V2500 Propulsion System — Nacelle

SERVICE BULLETIN

Subject: Transmittal of Revision 6 to Service Bulletin Number V2500-NAC-78-0132

NACELLE - EXHAUST - BLOCKER DOOR HINGE, TRANSLATING SLEEVE -
REPLACEMENT OF

Thrust Reverser Translating Sleeve Blocker Door Hinge Replacement
Figure 1 (Sheet 5)

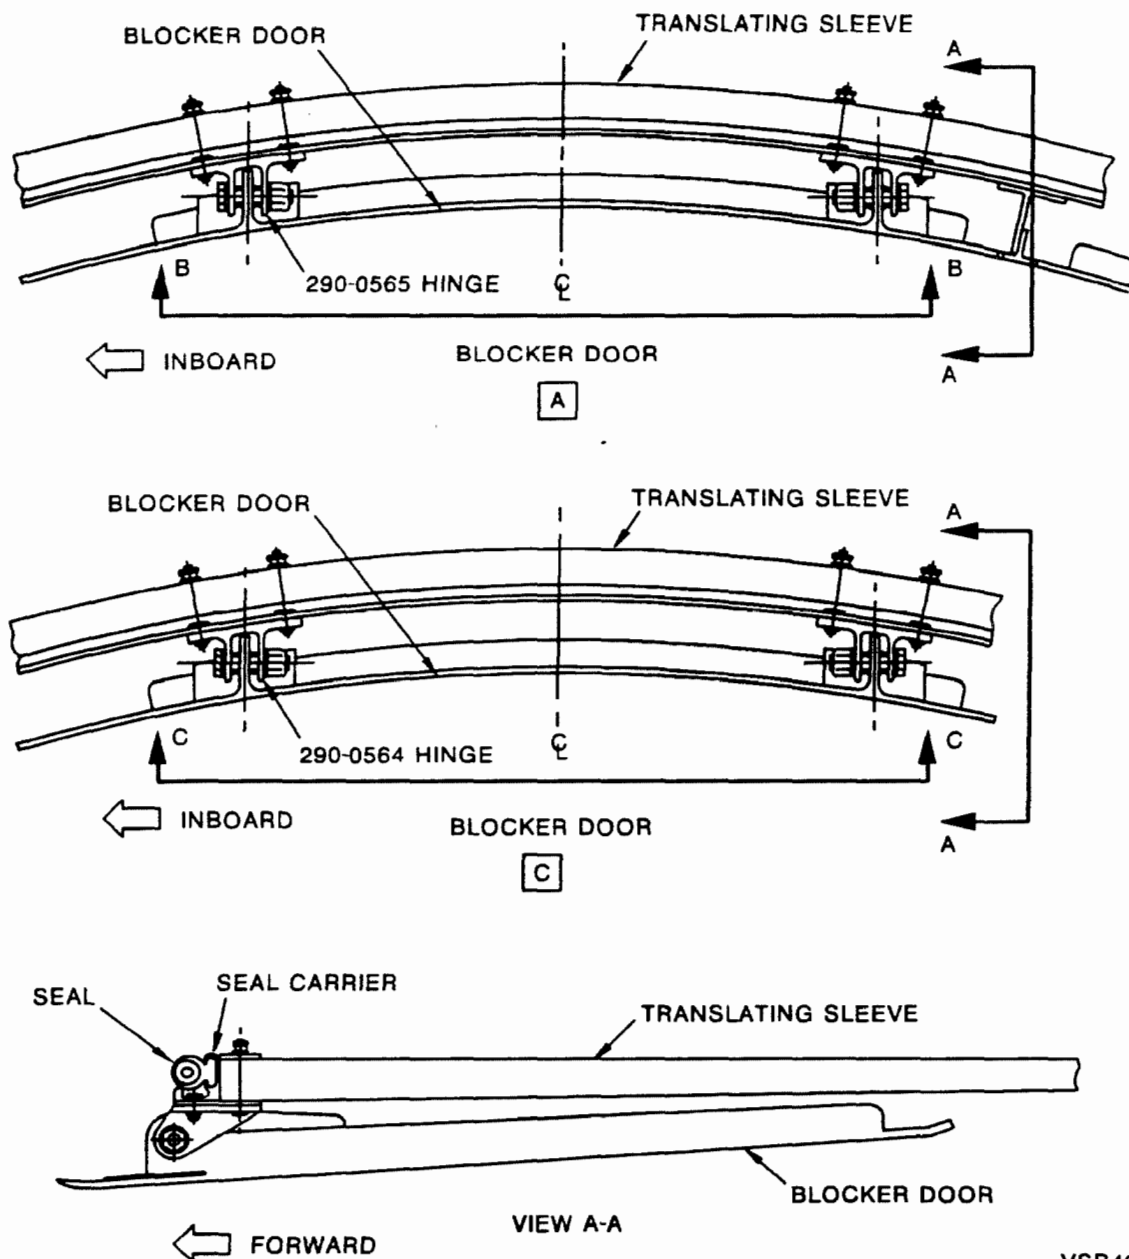
- (1) Remove the seal on the translating sleeve above the hinges to permit access to the hinge attaching hardware. Refer to Figure 1 (Sheet 5).

R NOTE: The seal is bonded with adhesive to the block seals
R at each end. Do not damage the seal or block seals.

Thrust Reverser Translating Sleeve Blocker Door Hinge Replacement Figure 1 (Sheet 7)

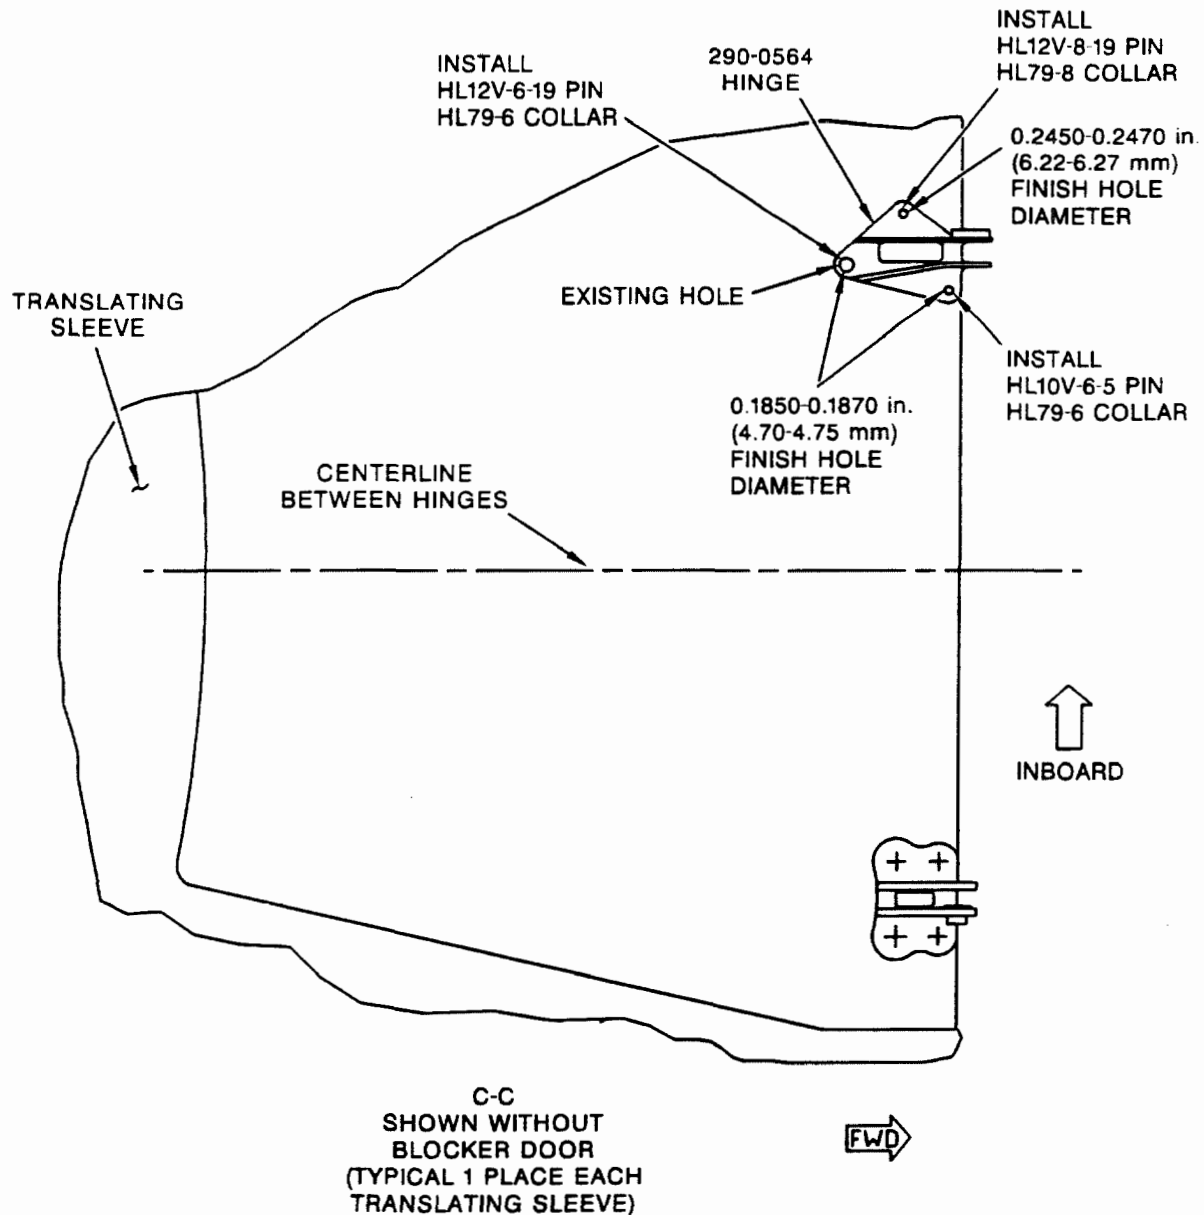
- R (f) Remove the hinge from the translating sleeve.
- R (g) Remove the burrs from the holes in the hinge.
- R (4) Prepare the replacement 290-0564 hinges for installation.
R Refer to Figure 1 (Sheet 7).

- R (c) Drill two 0.05 inch (1.27 mm) pilot holes in the
R hinge. Use a pilot drill bushing to hold the drill
R straight. Use the existing holes in the translating
R sleeve as a guide.

- R (d) Remove the blocker door from the hinges.
- R (e) Drill and ream the three holes to the finish
R diameters. Refer to Figure 1 (Sheet 7).
- R (f) Remove the hinge from the translating sleeve.

Thrust Reverser Translating Sleeve Blocker Door Hinge Replacement
Figure 1 (Sheet 8)

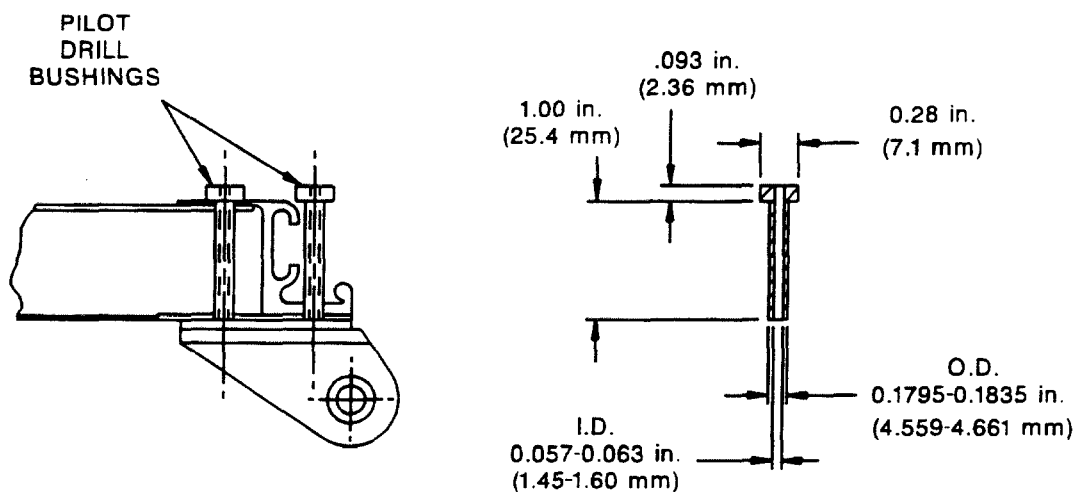
- R (c) Drill three 0.05 inch (1.27 mm) pilot holes in the
R hinge. Use a pilot drill bushing to hold the drill
R straight. Use the existing holes in the translating
R sleeve as a guide.
